RE: Independent Design Consultants Report

DESIGN CONSULTANT REPORT

76 PLACE *at Market East*

Design Review #1

Existing Context | Location Plan -Fashion District. Image source: November 2023 CDR submission

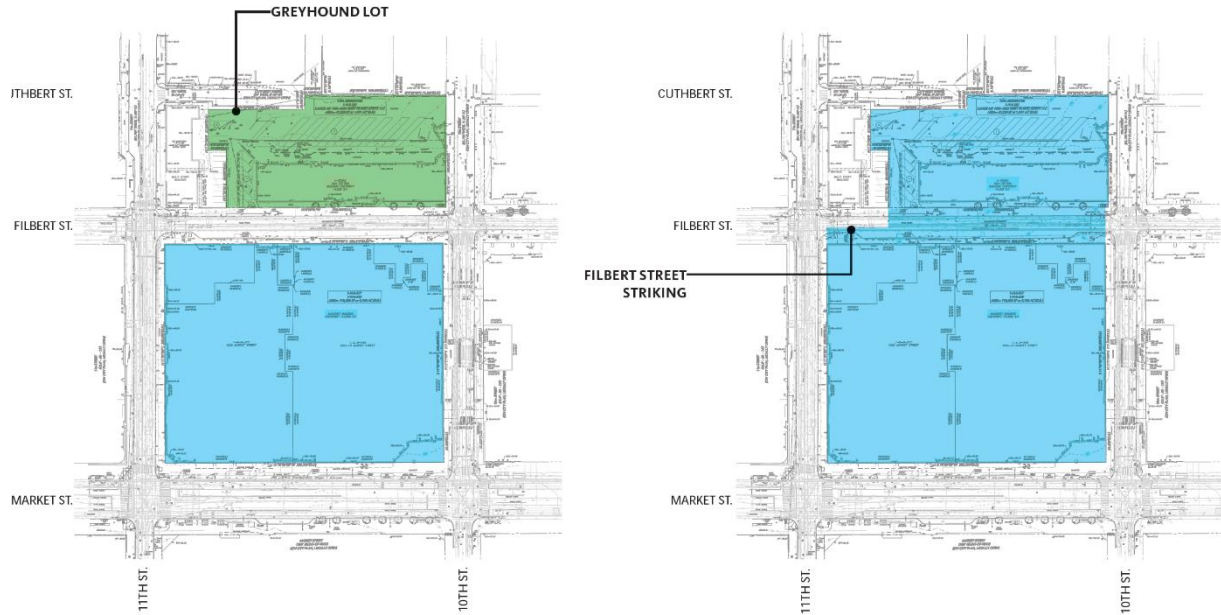
- 3. Site Boundaries:** The Review Team recognizes the extreme difficulty of acquiring and demolishing the parking structure and hotel that exist on the northwest corner of the block bounded by Market Street, 10th Street, 11th Street, and Cuthbert Street. This fact creates an excluded parcel that constrains the geometry of the arena in some manner. That said, the site proposed for the new arena is barely adequate in size for the proposed use.

Proposed | Lot Consolidation Plan. Image source: November 2023 CDR submission

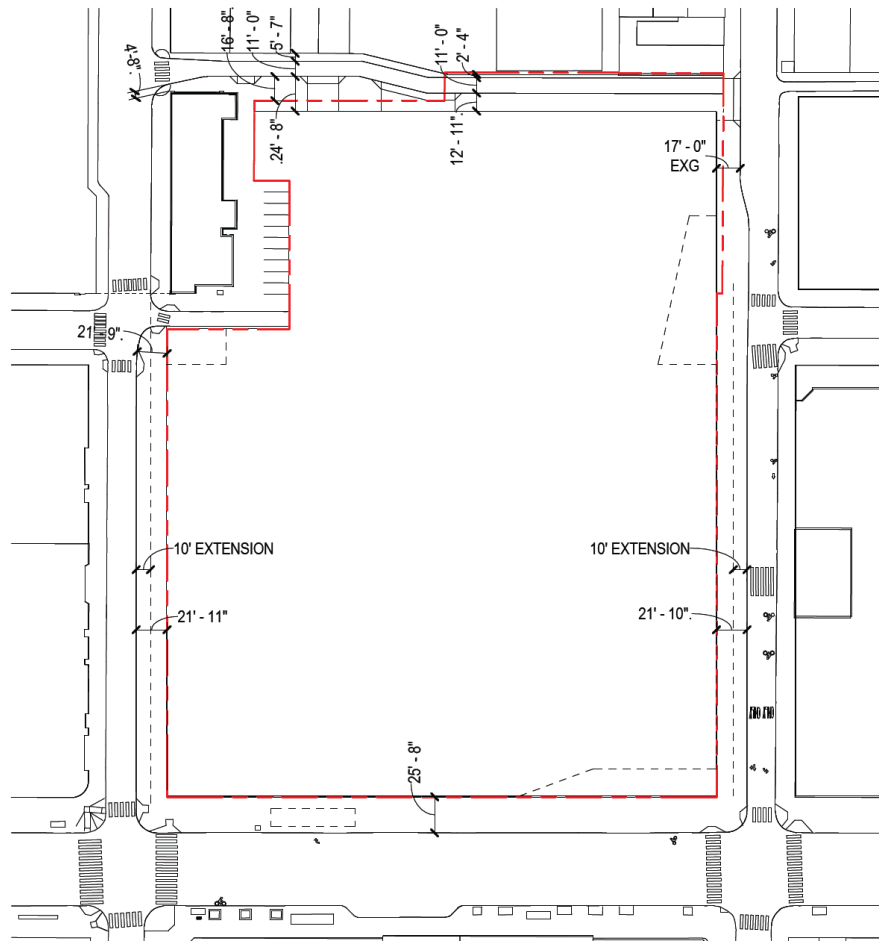
- 4. Striking of Filbert Street:** Vacating of any downtown right-of-way should be done with great caution. We believe that striking Filbert Street is appropriate given the overall dimensions and program for the new arena.

Proposed | Sidewalk Modifications. Image source: November 2023 CDR submission

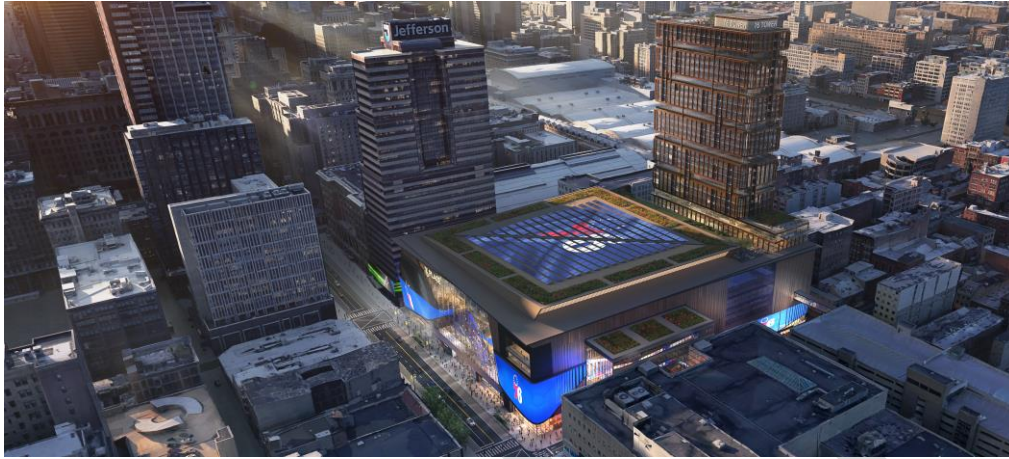
5. Sidewalk Widening: The Review Team agrees with the Developer that widening sidewalks on the four streets bordering the new arena (10th Street, Market Street, 11th Street, and Cuthbert Street) is entirely appropriate and will help to improve pedestrian circulation around the arena on event days. On non-event days, the wider sidewalks will be uncrowded. As to the specific dimensions of the sidewalks, while wider is better, we recognize that, except for Market Street, the existing street rights-of-way are not generous to begin with. We believe the proposed widenings are a reasonable compromise between the need for sufficient pedestrian flow and the need to preserve vehicular movement around the arena. Not widening the sidewalks would be a mistake, in our view.

Proposed Residential Tower (to right of arena). Image source: November 2023 CDR submission

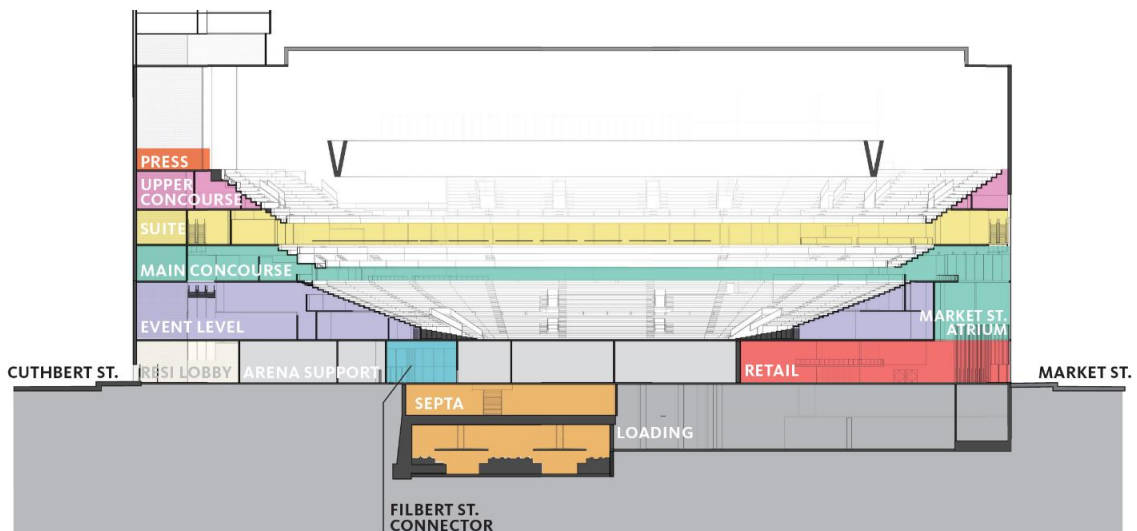
- 6. Residential Tower:** The Review Team commends the Developer for including a residential component in what is already a complex urban framework. We leave it to others to assess the appropriate level of affordable housing in the unit mix, but inclusion of multiple uses increases the urban vitality of the subject parcel by introducing pedestrian traffic at different times of day.

Proposed Market Street façade. Image source: November 2023 CDR submission

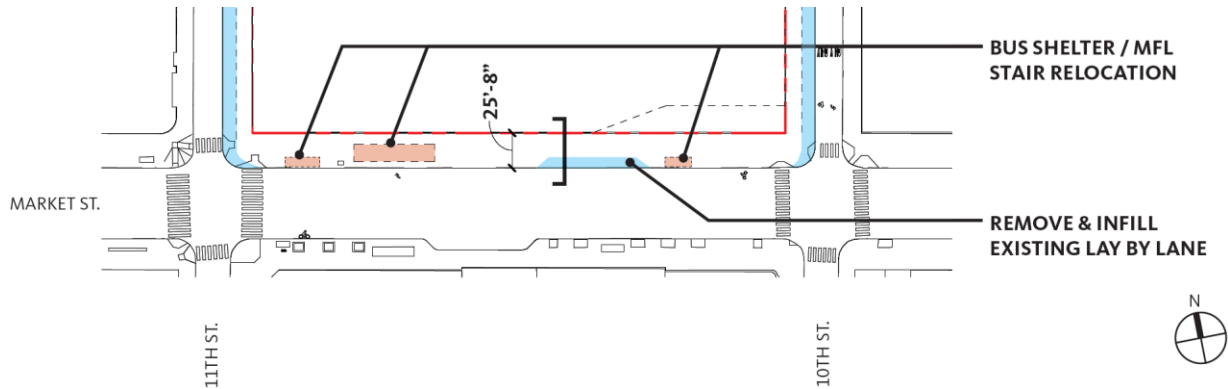
- 8. Transparency:** While the exact configuration of the building facades is still under development, we commend the degree of transparency suggested in the submitted renderings, which will help to activate Market Street, 10th Street and 11th Street. We also commend the high degree of transparency shown at the 10th Street bridge connection to the Fashion District Mall.

Decluttering Market Street sidewalk. Image source: November 2023 CDR submission

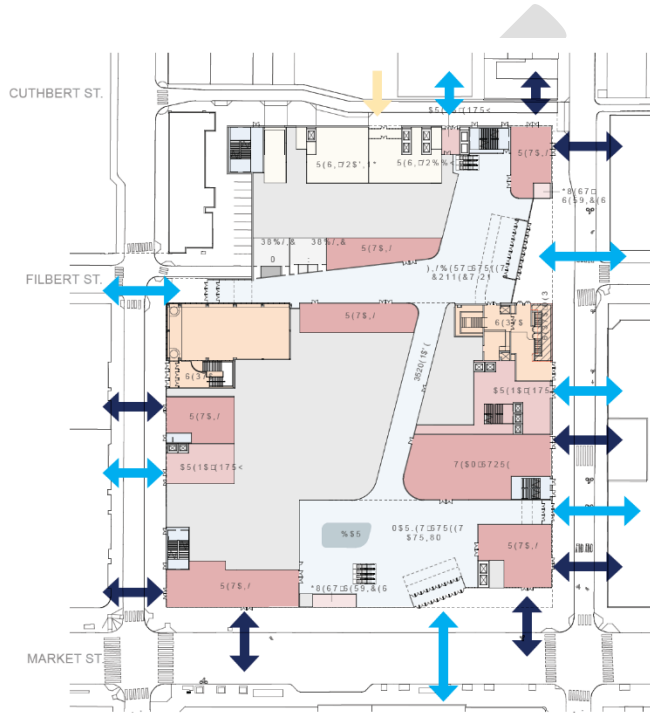
10. Decluttering Market Street: We agree that the relocation of transit stops and subway entrances from Market Street between 10th and 11th Streets adjacent to the arena site is a good idea, creating needed space for event day pedestrian access and flow.

Proposed | Plans - Street Level. Image source: November 2023 CDR submission

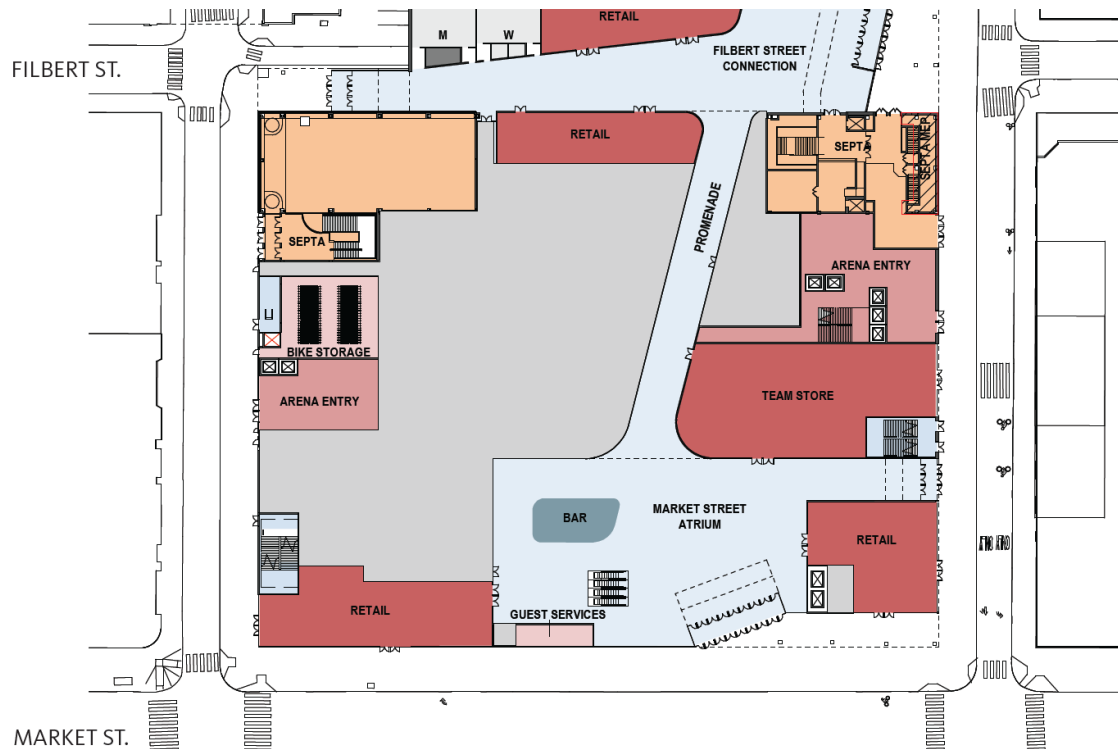
12. Distributed Access: In order for arena crowds to arrive and disperse without undue congestion on local streets, multiple points of arrival and departure are necessary. While we think that the southeast entrance (at 10th and Market Streets) will effectively serve as the venue’s front door, having a number of other entries for ticketed events (not to mention SEPTA’s Jefferson Station) will be crucial to avoiding excessive crowds on the surrounding streets. It should go without saying that entrances to the SEPTA station must be accessible at all hours of SEPTA operation, regardless of event activity (or inactivity). The broad distribution of access points for spectators, premium spectators, residents, and transit patrons is thoughtful and generally logical.

Ground Floor Plan. Image source: November 2023 CDR submission

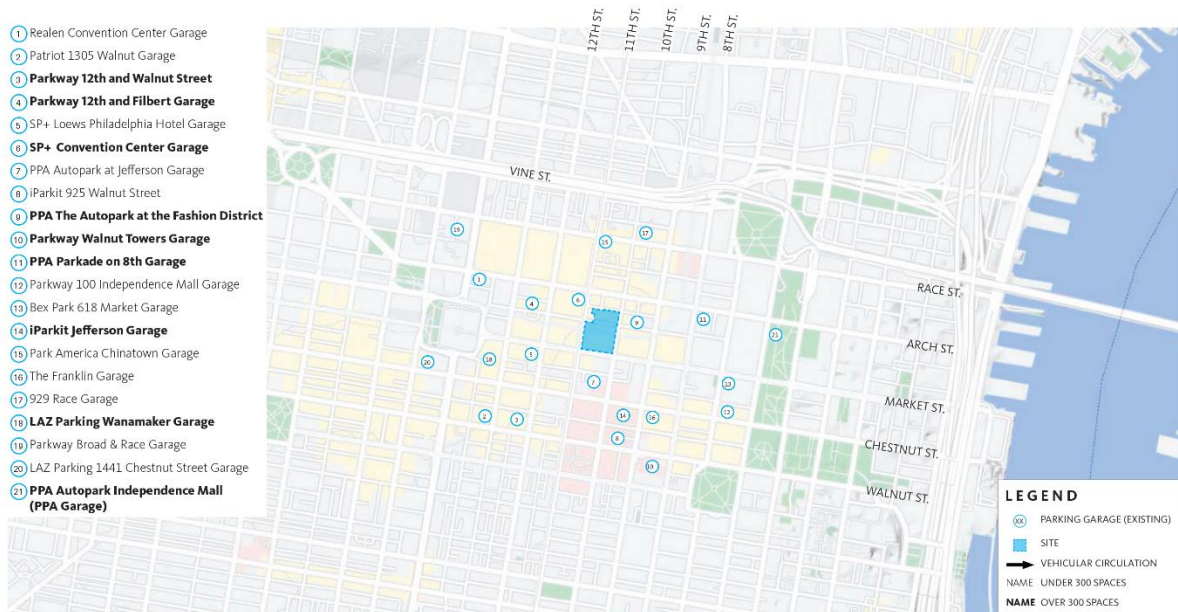
- 1. Ground Floor Plan:** The Ground Floor Plan, as submitted, includes a large amount of undesignated space which presumably is for arena support functions that require grade level access. Given the importance of this level to the overall success of the public realm and urban design, we request that a more complete floor plan be provided.

Proposed | Existing Site Loading (2 Levels Below St.). Image source: November 2023 CDR submission

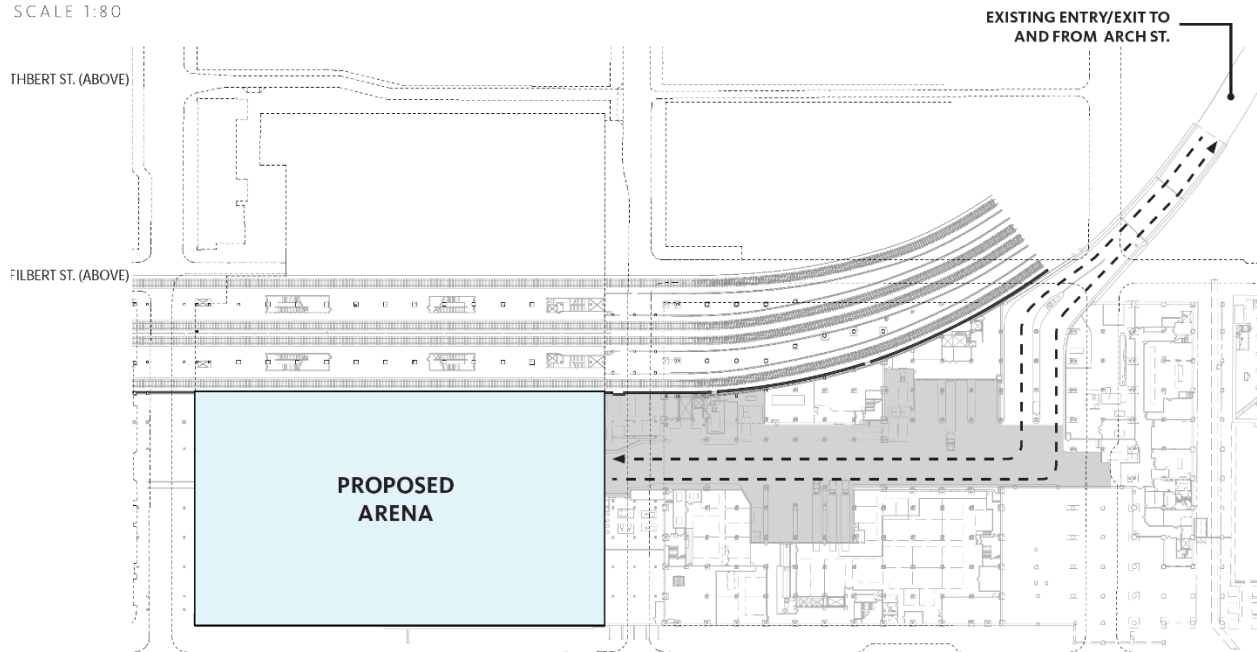
- 6. Sustainability:** The submission acknowledges a commitment to sustainability but does not make any concrete statement regarding sustainability goals or certifications that will be sought for the project.
- 7. Loading:** We are interested to see how trucks arrive at the arena loading area, truck turning movements, and the location of freight elevators in the project plans. None of these are clear from the submittal.

*Section – Proposed 10th St. Bridge Boundary.
 Image source: November 2023 CDR submission*

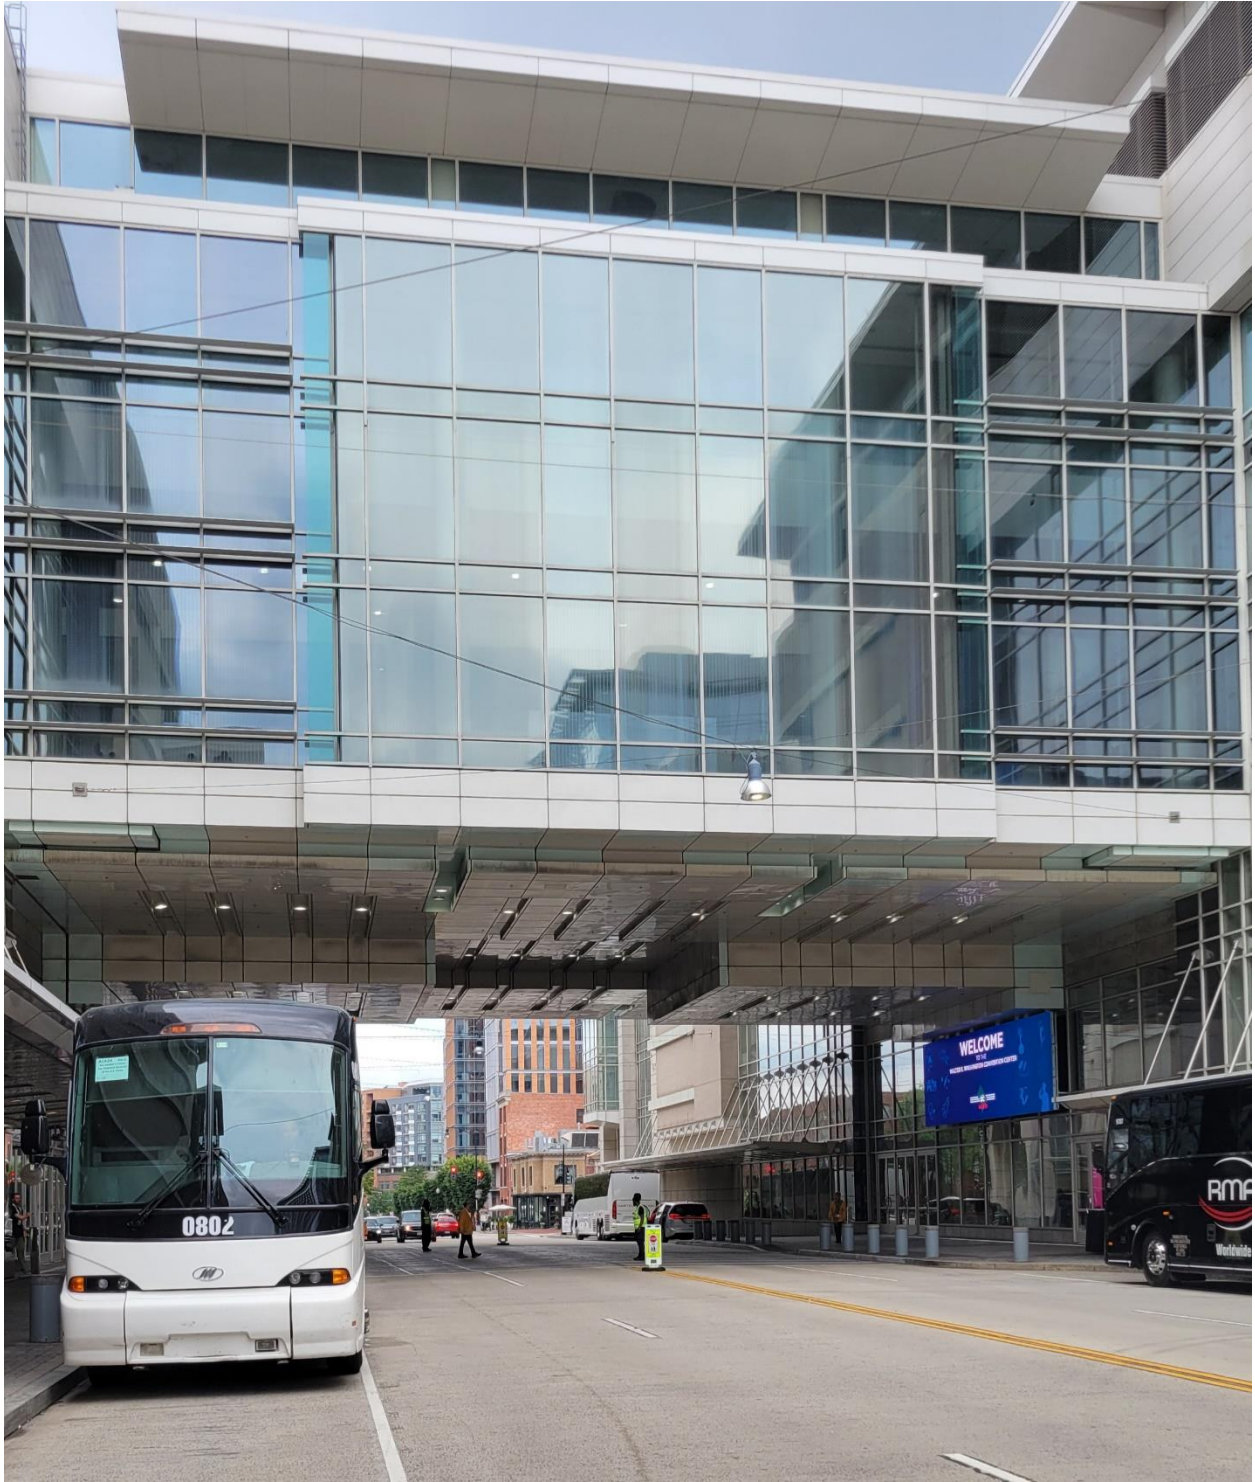
2. 10th Street Bridge: Large bridges over public streets are always a public concern, because they close off daylight and sky exposure. We recommend that the footprint of the 10th Street connection be as narrow as possible, that the bottom of the bridge (soffit elevation) be as high as possible, and that the architects pay special attention to the design of the underside of the bridge, since it is in the public right-of-way. Covered streets often seem too dark, poorly lit, and foreboding. Specific design attention should be paid to materials used and their reflectivity, in addition to adequate or unique lighting, and providing design details that showcase a welcoming and vibrant space. The photo below illustrates a high level of attention to a public walkway under a structure. The photo following shows a substantial vertical clearance under a building crossing over an urban street in Washington, DC; we estimate the vertical clearance at 27 feet. The proposed clearance of 19 feet 10 inches is substantially less than this.

Circulation | Pedestrian Study Arrival Door Splits. Image Source: November 2023 CDR submission

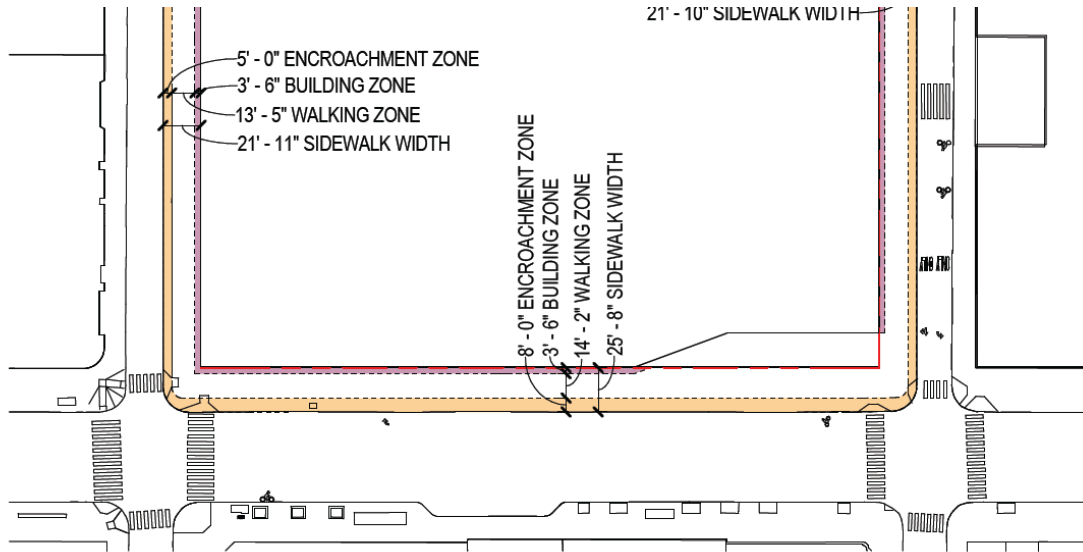
- 3. Structure:** The rendered views are optimistic, in our opinion, regarding the type and amount of structure required to hold up the arena and residential tower. Plans do not show columns for the most part. Our concern is that as structural concerns become more real, the character of the building will change substantially from what is shown in this CDR submission.
- 4. Exterior Surge Space:** While we don't disagree substantially with the estimates of pedestrians arriving at the various entries shown on Page 49 of the CDR submission, we are concerned that the surge space within the property line at 10th and Market Streets, as well as at 11th and Filbert Streets, is inadequate.

The Review Team would like to see the outdoor surge space at the 11th and Filbert Street entrance expanded and the vestibule pushed farther east. Regarding the 10th and Market Street entry, we can only observe that more space outside the entry would be better. Entries with lower volumes which propose doors nearly flush with the street wall are less of a concern, although any doors opening into the right-of-way should be recessed or designed to minimize potential conflicts with sidewalk users.

Proposed | Market St. At 11th St. Image source: November 2023 CDR submission

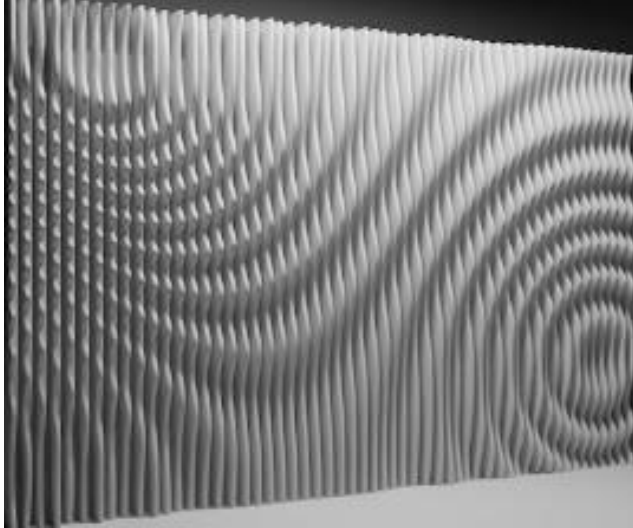
- 7. Exterior Signage:** While we acknowledge that dynamic LED-board exterior signage is typical and somewhat expected at new urban arenas, the amount of LED signage visible from Market Street, 10th Street, 11th Street, and Cuthbert Street needs to be carefully managed. The amount of signage shown in the submitted rendering along Market Street feels proportionate, with smaller amounts along 10th and 11th Streets, and relatively little along Cuthbert Street, which is where the entrance to the residential tower is to be located. We expect the amount of signage to be the subject of a detailed negotiation between the City and the Development Team. Our initial impression is that LED signage shown in the CDR submission is only one approach to creating a unique façade or attractive building, but should be recognized as a singular element, and not precedent setting for animated electronic signage for the corridor.
